SECTION 1.0 INTRODUCTION

This document, together with the Draft Environmental Impact Report (Draft EIR), constitutes the Final EIR for the Wat Khmer Kampuchea Krom (WKKK) Temple Project.

Figure 6

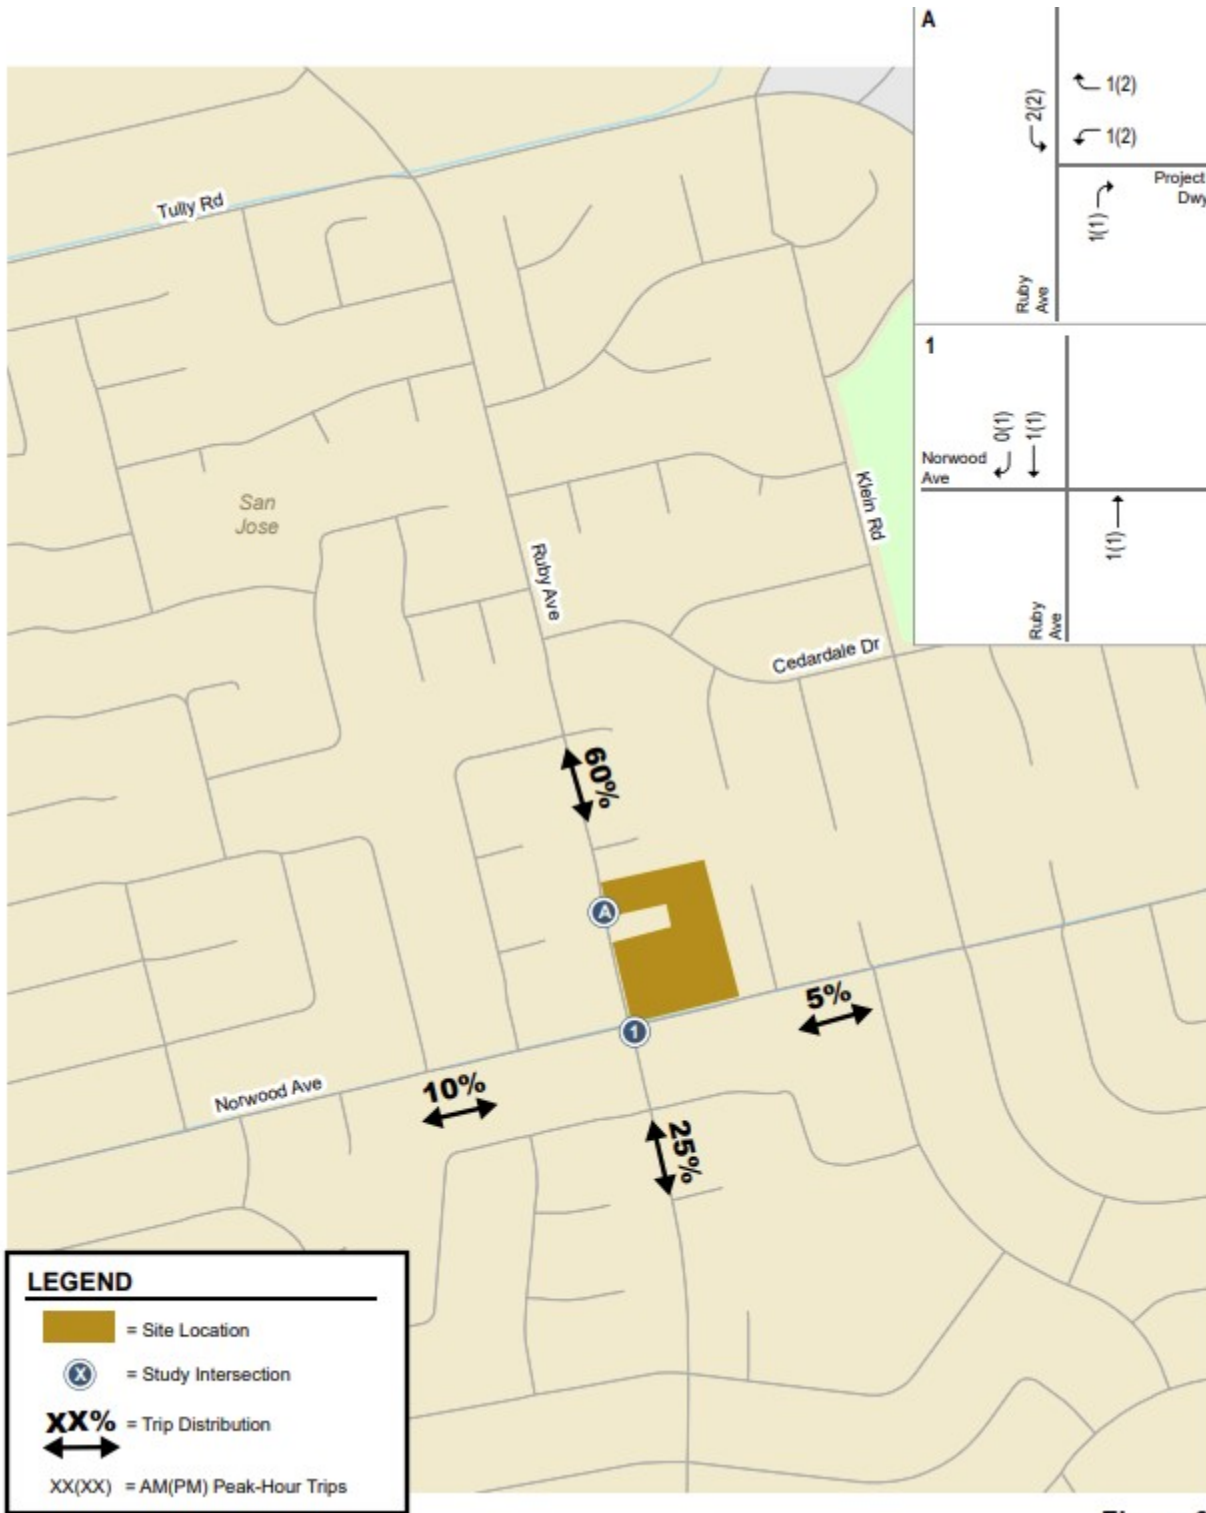
2. The temple only has one entrance (A) shown below, but on Ruby Ave, the traffic flow is opposite to the entrance when using Tully->Ruby. In this case, most cars will try to make a u-turn by making a left on Norwood, and perform the U-turn using Mantis/Bareoak Ct. This creates dangerous situation for traffic on Norwood and Mantis. How will the city address this issue.

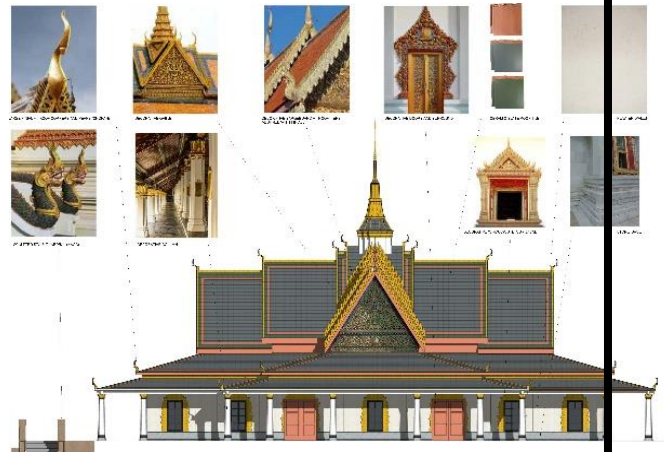
10. A visualization of the proposed temple with respect to the neighborhood, especially the small existing home at 2720 Ruby Ave surrounded on 3 sides by the proposed project, the temple would be COMPLETELY OVERSIZED, out of character for this small lot of land. It is also ESTHETICALLY NON-COMPATIBLE.

INCONSISTENT - DECEIVING OCCUPANCY CAPACITY

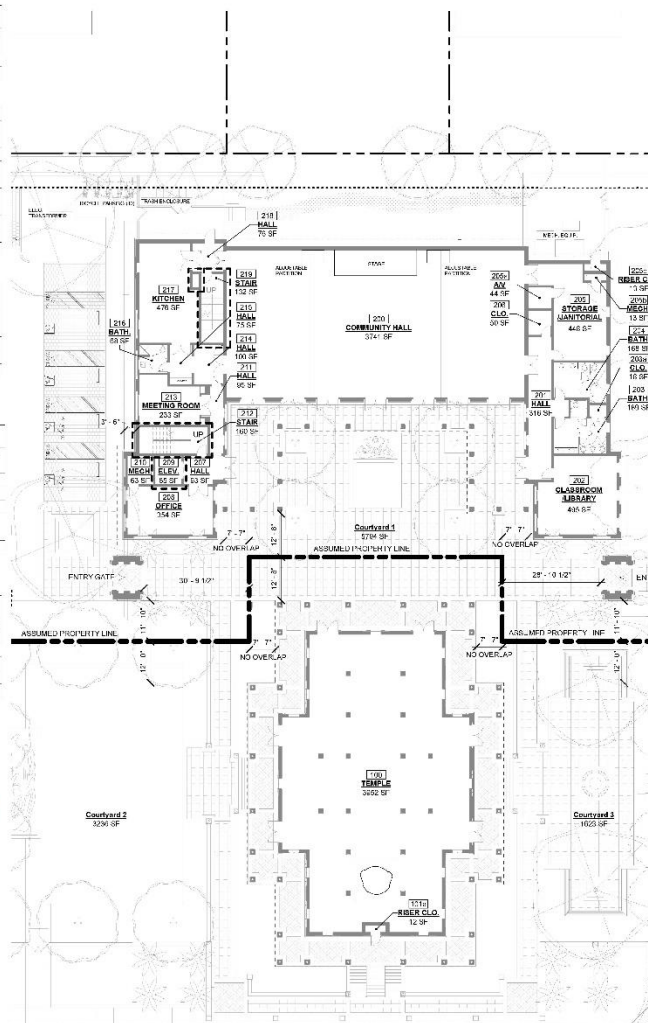
Courtyard Occupant Load					
Number	Name	Area	Occupancy	Occupant Factor	Occupant Load
01	Courtyard 1	5794 SF	Assembly Concentrated	5 SF	1159
02	Courtyard 2	3236 SF	Assembly Concentrated	5 SF	648
03	Courtyard 3	1623 SF	Assembly Concentrated	5 SF	325
					2132

OCCUPANT LOADS REPRESENT BUILDING DEPARTMENT EGRESS ANALYSIS PER CBC TABLE 1004.5 AND DO NOT REPRESENT ACTUAL EXPECTED BUILDING ATTENDANCE.

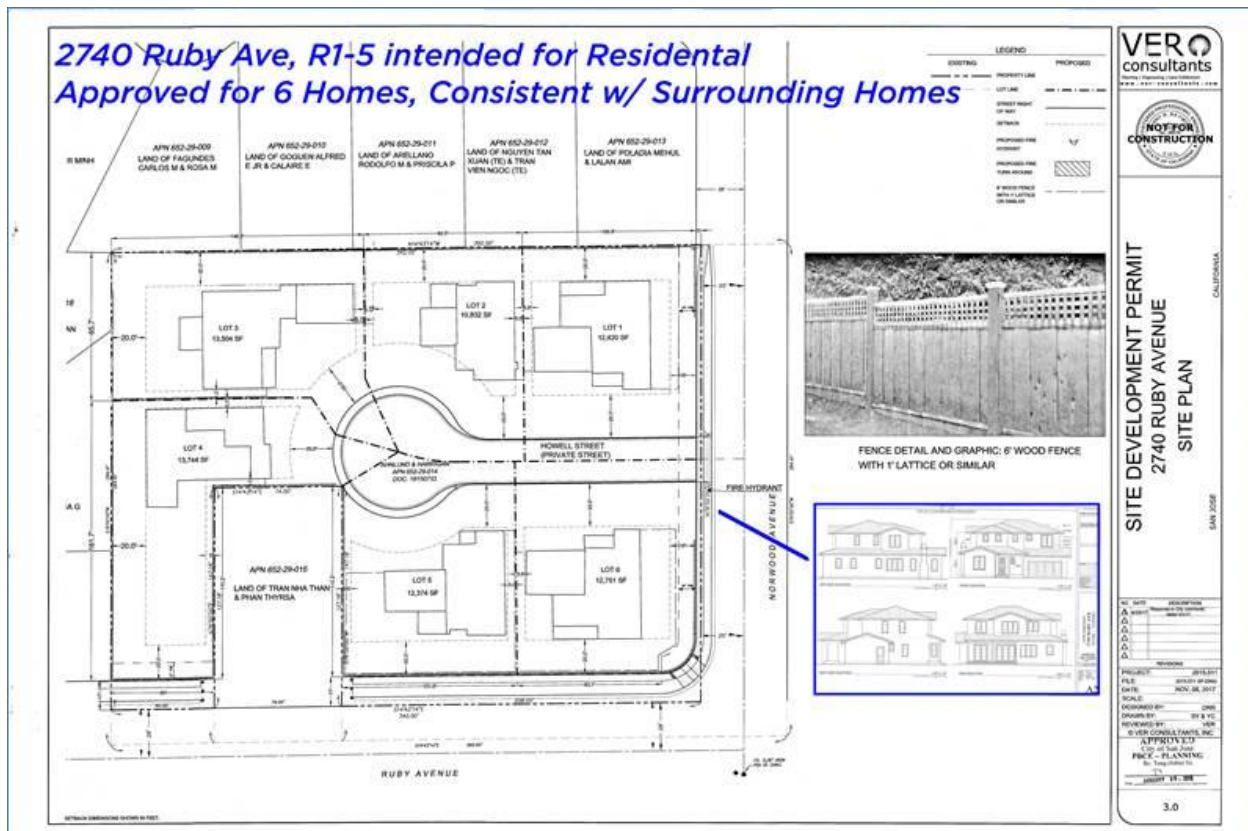
The proposed project may be inconsistent with the following General Plan policy:

Land Use Policy LU – 10.8: Encourage the location of schools, private community gathering facilities, and other public/quasi-public uses within or adjacent to Urban Villages and other growth areas and encourage these uses to be developed in an urban form and in a mixed-use configuration.

The proposed project would need to be compatible with the surrounding neighborhood. A detailed analysis and operation plan needs to be provided as part of a formal application submittal. Additionally, the building layout and design would need to be compatible with the existing neighborhood (frontage patterns, building setbacks, curb cuts). Additionally, staff would be analyzing the operation of the subject site and traffic pattern. Please also note that details comments were not provided as site layout and building designs were not requested and, therefore, not included in this review.
